RE: Storm Water Inspection

ADEQ Water NPDES Inspection	AFIN: None	Permit #: None

Water Division NPDES Photographic Evidence Sheet							
Location: On the south side of Greers Ferry, Arkansas on Highway #16 (Cleburne County)							
Photographer: Mike Kennedy Witness: None

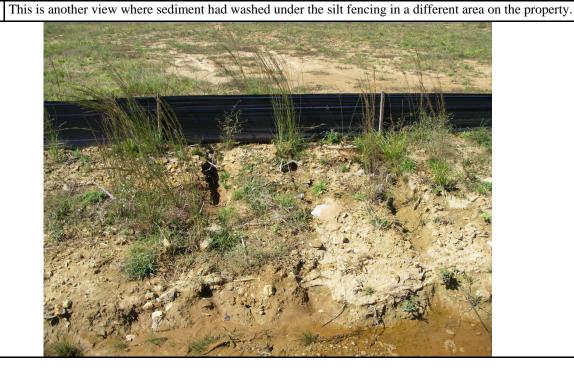
I also noted that you have an area of bare ground with no vegetative cover that is approximately 1 acre in size. Vegetative cover needs to be established as soon as possible. A suggestion might be to put out mulch or hay to cover the ground before the fall and winter rains.

Water Division NPDES Photographic Evidence Sheet									
Location:	Location: On the south side of Greers Ferry, Arkansas on Highway #16 (Cleburne County)								
Photographer:	apher: Mike Kennedy Witness: None								
Photo #	3	3	Of	8		Date:	10-10-07	Time:	1217
Description: Note the bare ground located on the East side of the branch with a wet weather stream running through the bar The bare area covers approx. more than 1 acre.									ugh the bare ground.

Gresponse to your letter daled Nov 16, 2007 I have purchased a truck load of 3" to 4" washed white stone that will be placed along the needed areas of the selt fencing and in the areas "in The ditch" where the Hay Bales Continue to be washed away from large rains. Also, I have Durchased and rec 20 addetional Hay Bales to be squad and placed on the have area, as you indicated, We will plant seed before placing & dist. the Hay. The Botone has been delivered, and should be placed this next week, as it was too muddy tweet for placement. The Hay well be spread as soon as we finish the Rock work.

3 T	Water Division NPDES Photographic Evidence Sheet									
Ī	Location: On the south side of Greers Ferry, Arkansas on Highway #16 (Cleburne County)									
Ţ	Photographer: Mike Kennedy Witness: None									
	7	7 Of 8 Date: 10-10-07 Time:

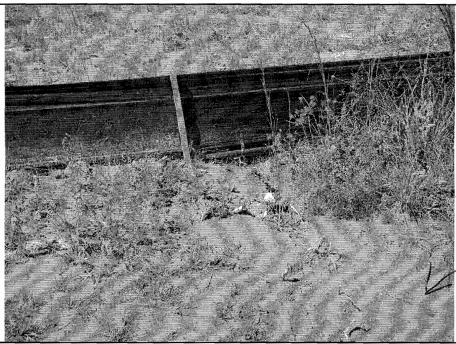
This view shows a different area where sediment had washed under the silt fencing into the branch.

Rockalse
Where the
Hay Bales
Run accross
the Detch
to Slow down
the Water Flow
